Tech Alert

Replacing PA78DK with PA79DK in Existing Applications

Figure 1

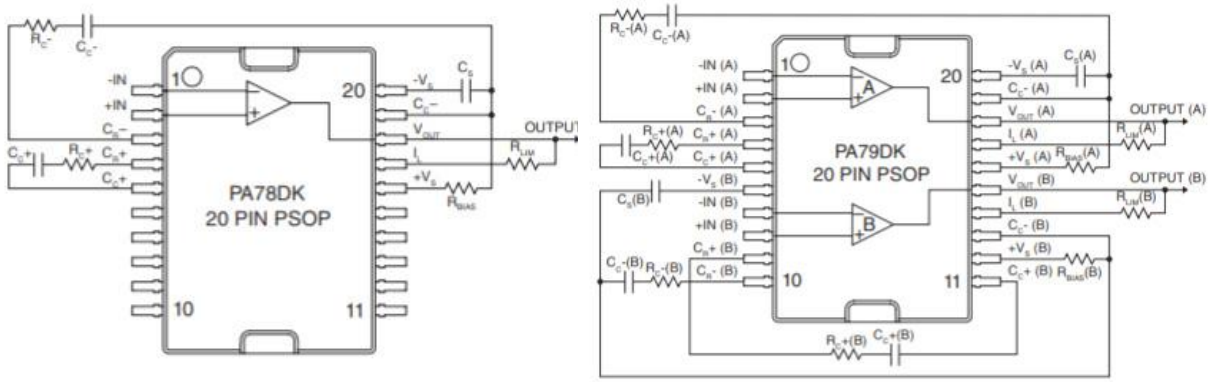
These devices offer identical form factors and both utilize the same 20 PIN PSOP package (Apex's 'DK' package designation), have the same specifications, and are similarly behaved, with the only effective difference being that the PA79DK is a dual channel amplifier while the PA78DK is a single channel amplifier. The PA78DK's pinout is identical to the PA79DK's "A" channel pinout, but the unconnected pins (pins 6 through 15) on PA78DK are used for the PA79DK's "B" channel as illustrated in **Figure 1.** below:

Apex recommends that a PA79DK can be used in place of a PA78DK in applications where pins 6 through 15 are not connected to any power or signal traces on the PCB layout and are either floating or connected to ground.
